Proposal for Supplement 3 to the 02 series of amendments to UN Regulation No. 129 (Enhanced Child Restraint Systems)

Submitted by the Working Party on Passive Safety*

Supplement 3 to the 02 series of amendments to UN Regulation No. 129 (Enhanced Child Restraint Systems)

"Figure 3

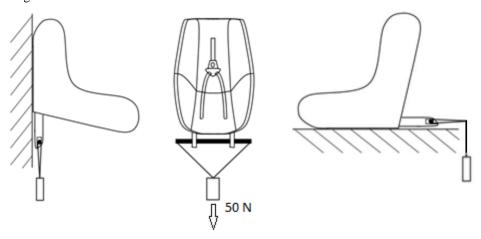
"7.2.8. The complete seat, or the component fitted with ISOFIX attachments (e.g. ISOFIX base) if it has a release button, is attached rigidly to a test rig in such a way that ISOFIX connectors are aligned as shown in Figure 3. A 6 mm diameter bar, 350 mm long, shall be attached to the ISOFIX connectors. A force of 50 ± 1 N shall be applied to the extremities of the bar."

Figure 3, amend to read:
